To:	Dunedin City Council	From:	Edward Guerreiro
		Review:	Lee Paterson
File:	2GP Rezoning sites_ March2022	Date:	May 6, 2022

## SUMMARY

The purpose of this letter is to transmit our assessment the hazards and respond to public submissions at the requested sites:

Figure 1 – 155 and 252 Scroggs Hill Road Site

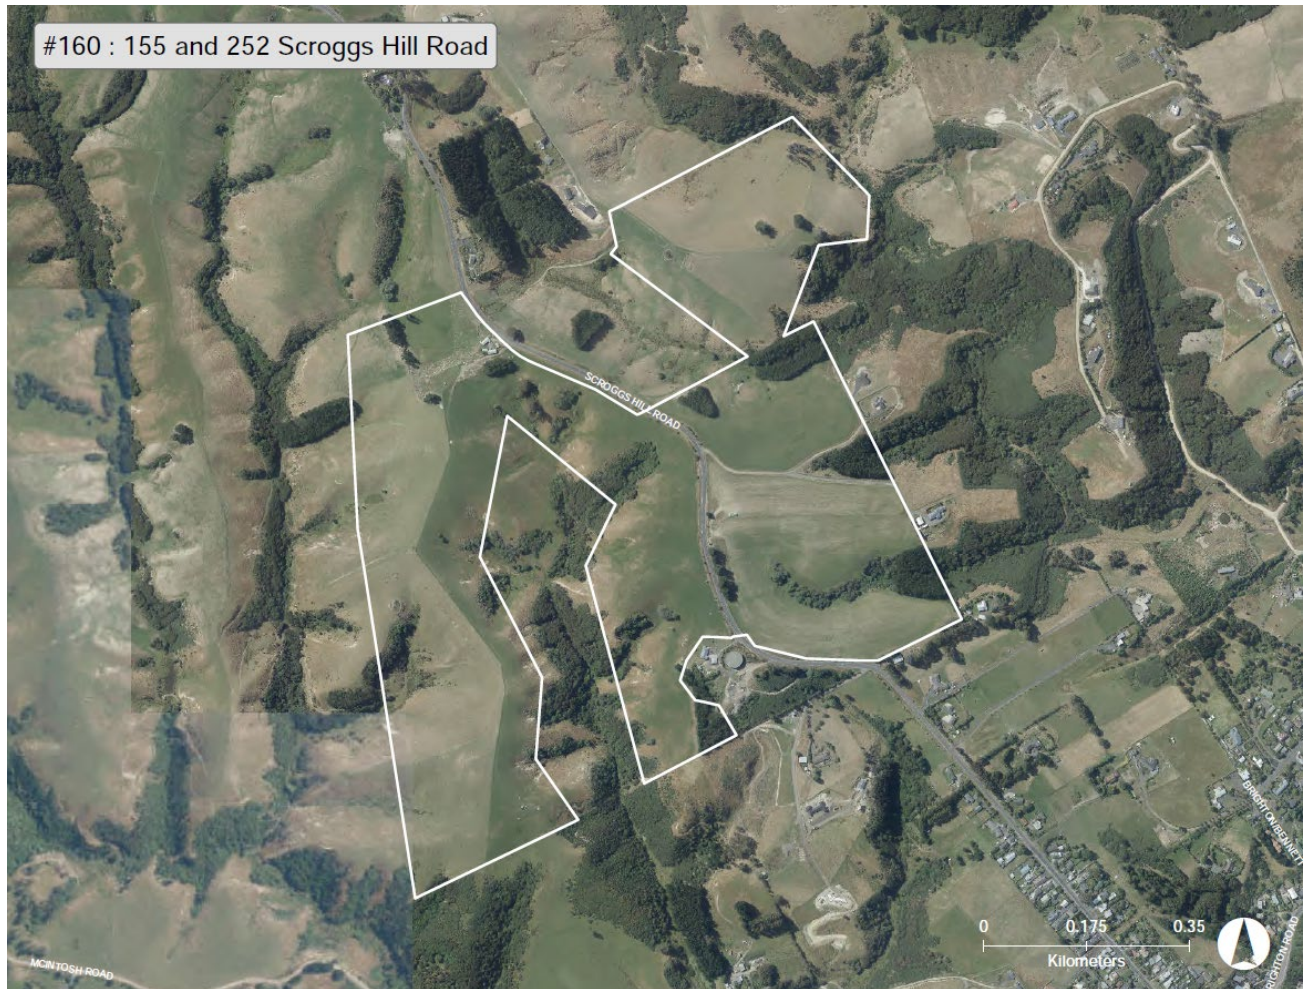
- S249.001 & S249.003 (Ross McLeary & COF Ltd & Scroggs Hill Farm Ltd): Request to rezone the site from Rural Residential 1 zone to Township and Settlement Zone with a Structure Plan Mapped Area (inferred not stated).
  - The effective change is to very slightly increase/vary the site boundaries of the original assessment.

We have reviewed the above submission and related documents and recommend that the original assessment is relevant and there is **no change** from the original assessment.

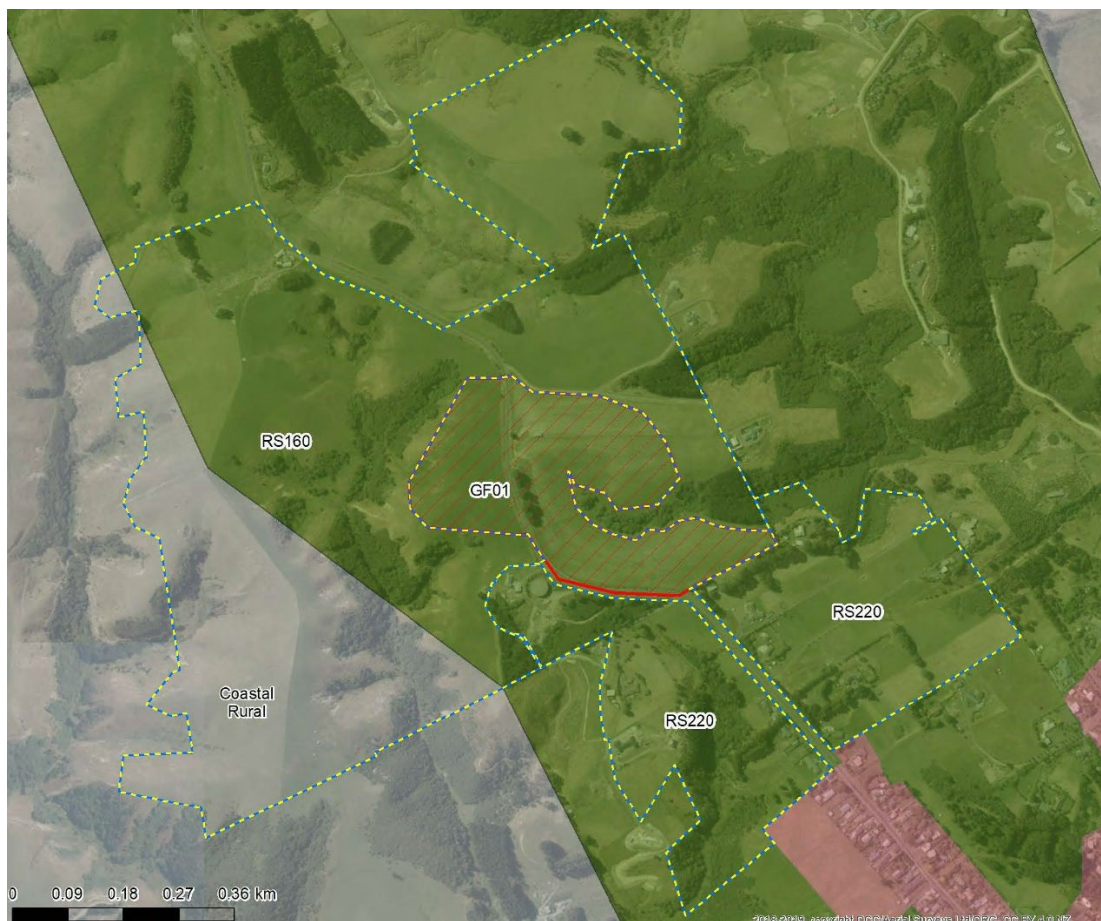
The proposed new rezoning area is shown in the figure below.
